DEPARTMENT OF PLANNING  
STAFF REPORT

## PLANNING COMMISSION PUBLIC HEARING

**DATE OF HEARING: March 19, 2009**

**SPEX 2008-0042, SPEX 2008-0067 & ZMOD 2008-0015 – The Compass School**

Proposed building and parking layout; the building is noted in blue, Parking areas in yellow, and the play area in green.

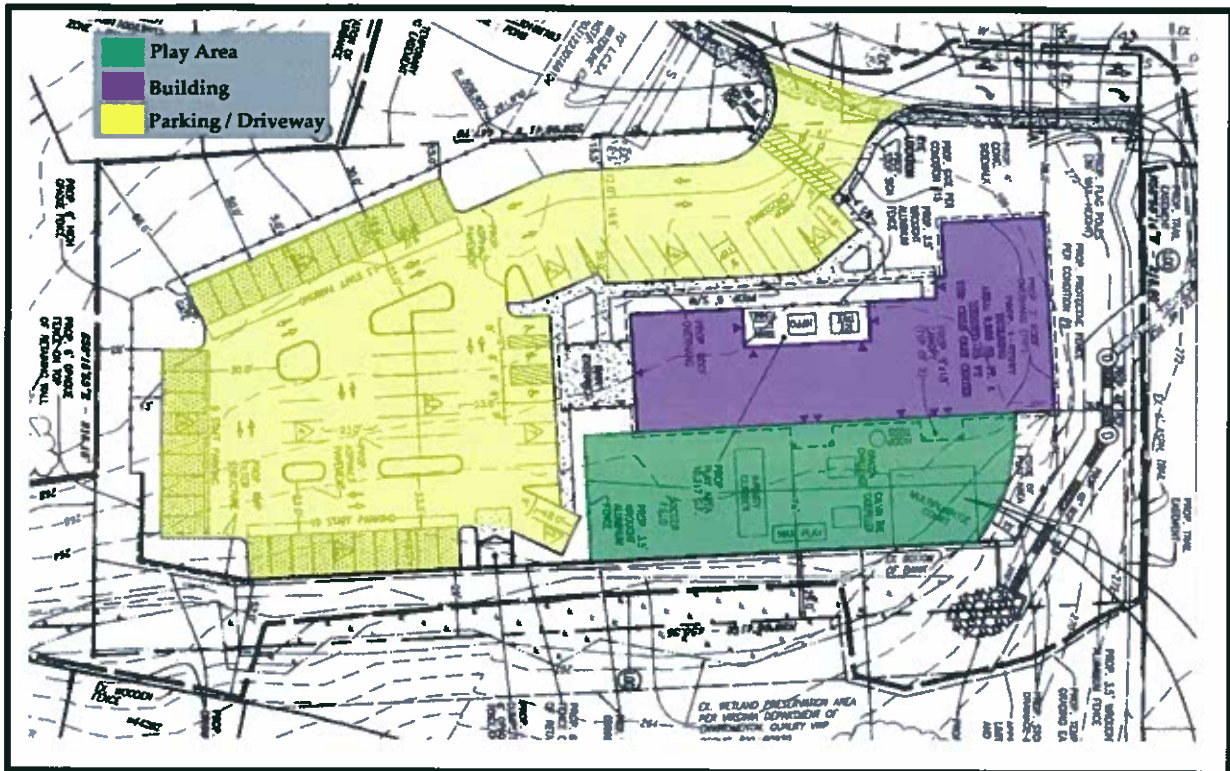
**Staff Review and Recommendation:** Staff cannot support this modification. Staff acknowledges that a modification (ZMOD 2005-0007) to reduce the parking and building setback was approved as part of the Busy Kids Learning Center application. As this application was vetted by the Planning Commission and Board of Supervisors, the scope of the modifications were reduced such that the majority of the building, notably that portion adjacent to existing or proposed residences, could be accommodated within the seventy-five (75) foot building setback. In like manner, the scope of the parking modification was reduced to fifteen (15) feet at its narrowest point. The parking lot layout was revised to allow a greater setback of the parking areas from proposed or existing residences; a parking setback of thirty (30) feet from Lot 28, fifty (50) feet from Lot 29, and fifty-two (52) feet from Lot 36 was approved. In addition, the Applicant committed to construct a six (6) foot high fence, in addition to enhanced landscaping, around all parking areas to provide a buffer to nearby residences.

In contrast, the current application proposes to relocate the parking areas from the rear of the lot to an area adjacent to Russell Branch Parkway and Navajo Drive; a play area will now be located adjacent to the afore-mentioned residences. A fence will surround the play area and will maintain a uniform distance of approximately thirty-six (36) feet from Lots 28 and 29. A building setback of seventy-five (75) feet will be maintained along the north, south, and west

boundaries but a reduction to twenty nine (29) feet is proposed along the east boundary line. As depicted on a conceptual grading plan, this orientation will require a retaining wall approximately twenty-five (25) feet from the property line.

The proposed modifications represent a sixty-one percent (61%) reduction in the building setback and a seventy-five percent (75%) reduction in the parking setback. The Applicant justifies the proposed reduction in the building setback by stating a Type 2 Buffer will be planted along the eastern boundary line. The Applicant further states that existing vegetation located on property owned and controlled by the Ashbrook HOA will augment this buffer and provide further screening from the adjacent residential community. Staff notes that this shared boundary between the HOA and the subject site contains an area of existing wetlands and also serves as a drainage easement for commercial properties located across Russell Branch Parkway. The reduction in building setback will place the proposed building in closer proximity to both. The Special Exception Plat depicts an existing wetland preservation area but this area will coincide and potentially conflict with both the area needed to accommodate the Type 2 Buffer and the drainage easement. Further, the retaining wall will essentially hard line the wetland preservation area on one side and may result in increased water flow through the drainage easement and along the rear yard lines of Lots 35, 36, 37, and 38.

This proposed modification will result in a building substantially larger than what could otherwise be accommodated on this site. The intent of a modification is to achieve an innovative design, improve upon the existing regulations, or otherwise exceed the public purpose. The intent of a modification is not to achieve the maximum density on a site, as seems to be the case here.

Environmental features impacted by the proposed building and parking layout.  
Information obtained from Loudoun County Department of Building and Development.

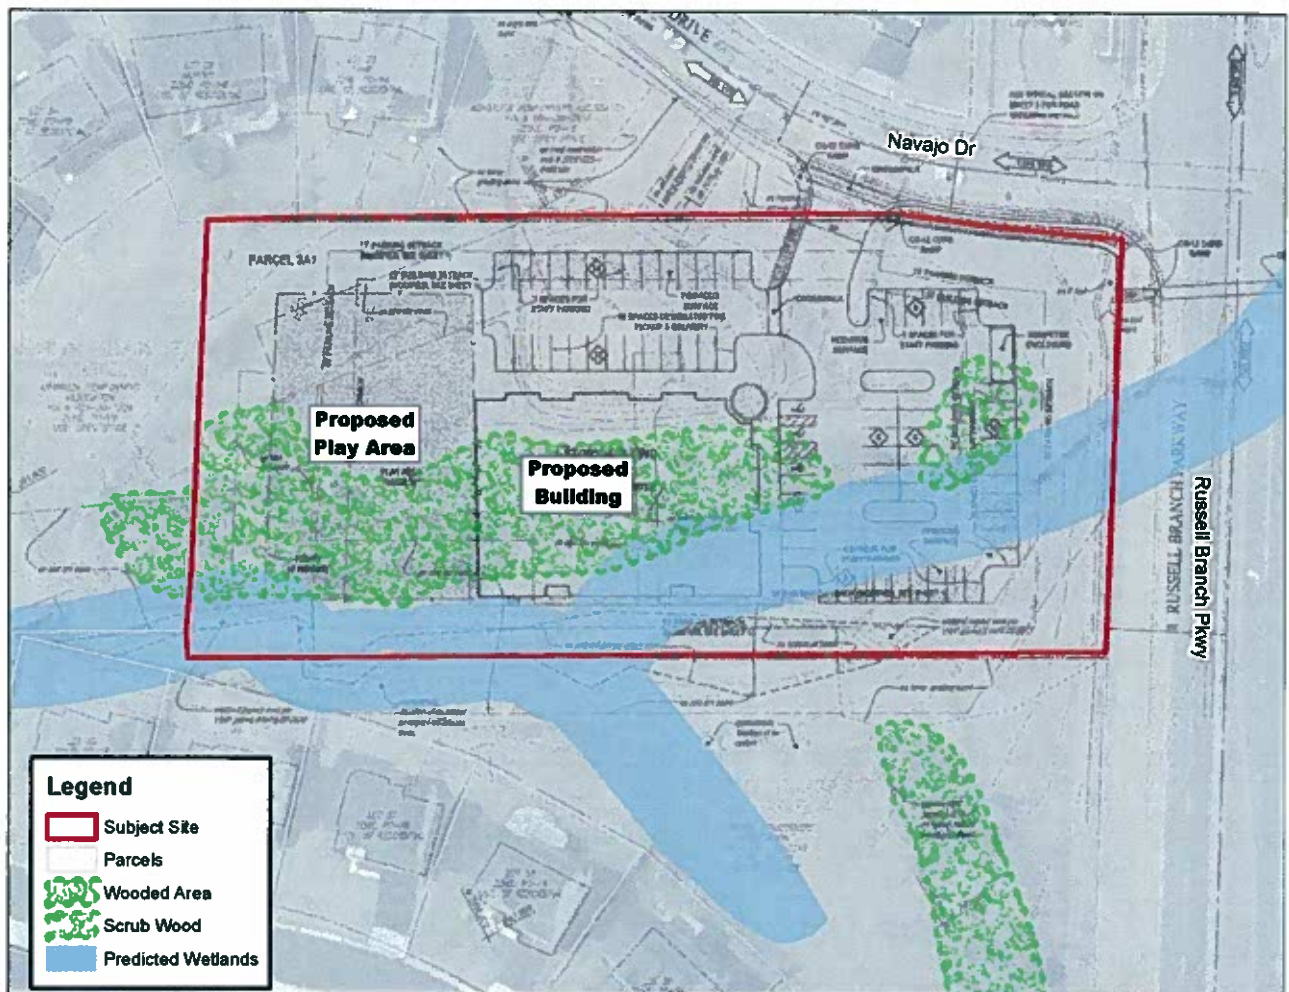
Existing wetlands are located both on and off-site along the property's eastern boundary. These wetlands have been formed, in part, by a drainage outlet running underneath Russell Branch Parkway and which discharges near the site's northern boundary. The majority of the wetlands located on-site will be impacted by the proposed building and associated parking area; however an existing wetland preservation area, measuring approximately fifteen (15) feet in width, is depicted on the subject site and follows the eastern boundary. Modifications to both the building and parking setback will place the building approximately fifteen (15) feet from the wetland preservation area. The placement of the building will necessitate a retaining wall, depicted on a conceptual grading plan, approximately twenty-five (25) feet from the property line, essentially hard-lining the wetland preservation area on one side. The required Type 2 Buffer will be located beyond the retaining wall and will coincide with the wetland preservation area. Specific implications of the modifications are discussed further in Section V.D. of this report.

Existing wetlands are currently located both on-site and on a piece of property along the eastern boundary line owned by the Ashbrook HOA. Though the Applicant has received approval to mitigate the on-site wetlands, a wetland preservation area has been delineated on the Special Exception Plat. A modification to reduce the building setbacks to twenty-nine (29) feet will locate the structure in close proximity to the wetland preservation area. Required buffer yards and a existing drainage easement will coincide and conflict with this area.
